STAFF RECOMMENDATION

NCPC File No. 5907

MARTIN LUTHER KING, JR. MEMORIAL TIDAL BASIN, WEST POTOMAC PARK Washington, D.C.

March 30, 2006

**MARTIN LUTHER KING, JR. MEMORIAL
REVISED CONCEPT SITE PLAN**

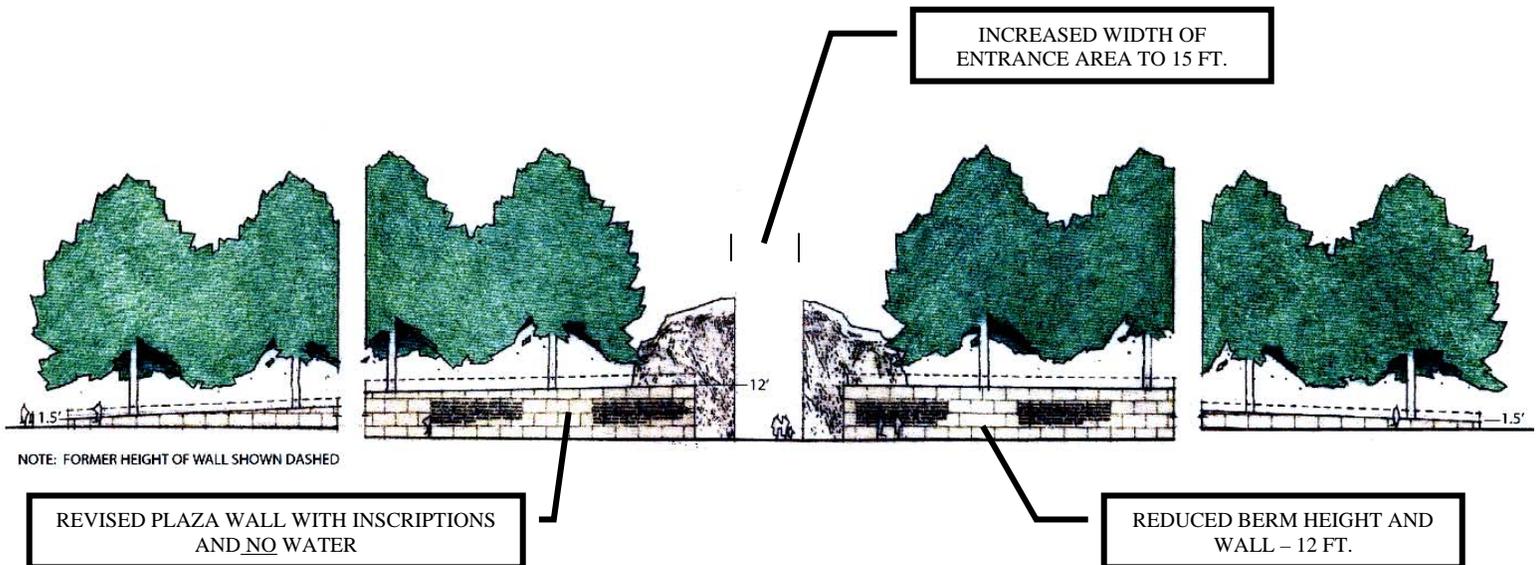
Staff is very pleased and satisfied with the revisions to the design concept for the memorial and recommends that the Commission comment favorably on the revised concept submitted. The staff commends the MLK Foundation for arriving at a simpler and refined focus to the Martin Luther King, Jr., Memorial. The revisions appropriately respond to the Commission’s earlier review comments. The changes achieve the following:

- The Mountain of Despair and the Stone of Hope are the signature elements of the memorial. At the entry portal, two stones remain parted with a more generous width to the pedestrian entry area than previously proposed, yet maintains the focused view through the foreground and into the plaza where the carving of Dr. King resides, emerging, as the Stone of Hope. The removal of the elevated bridge and memorial walk at the top of the landscaped berm is a very successful modification.

REVISED MEMORIAL BERM HEIGHT AS VIEWED FROM INDEPENDENCE AVENUE

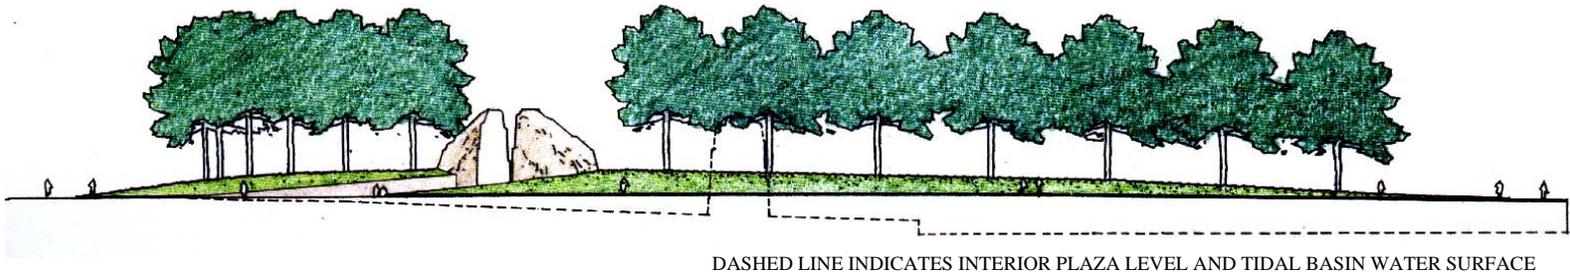
- The revised berm height (reduced by 2.5 feet) visually proves to be less imposing on the wide viewshed of the west end of the Tidal Basin and West Potomac Park, particularly with regard to the views from Independence Avenue.

DETAILS OF WATER FEATURES, BRIDGE, AND MEMORIAL WALK THAT WERE REMOVED FROM THE MEMORIAL CONCEPT DESIGN

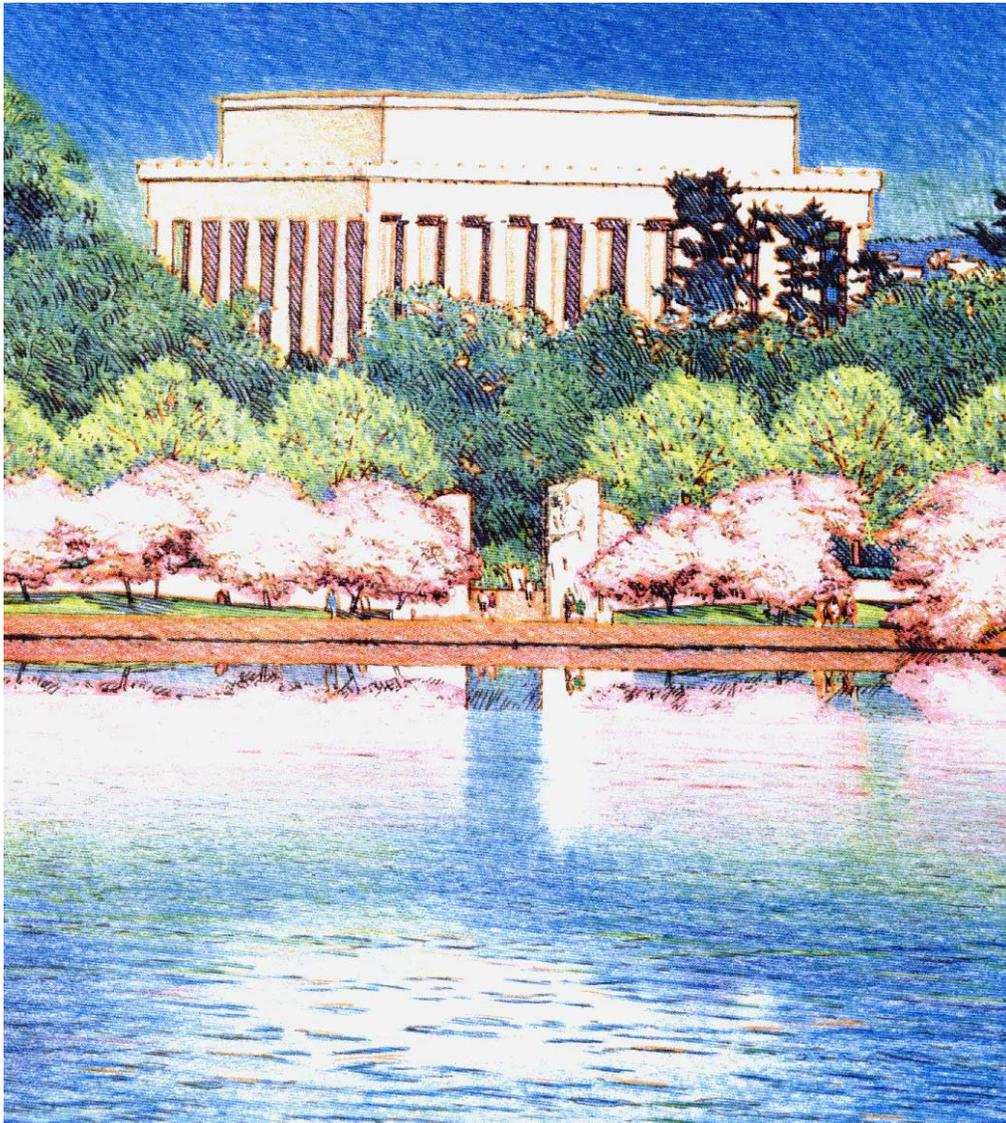
- The plaza wall at the berm (formerly the water wall, with its gradation of water intensity) now presents an opportunity of stronger visual focus to Dr. King’s orations through the unimpeded inscribed text area on the stone surface of the vertical wall.

Removal of the use of water in the memorial contributes fully to reducing flooding impacts to the memorial's infrastructure, and minimizes excavation and foundation impacts of the planned memorial site due to the reduced need for large pump areas and piping, and the associated maintenance areas required to support those features.
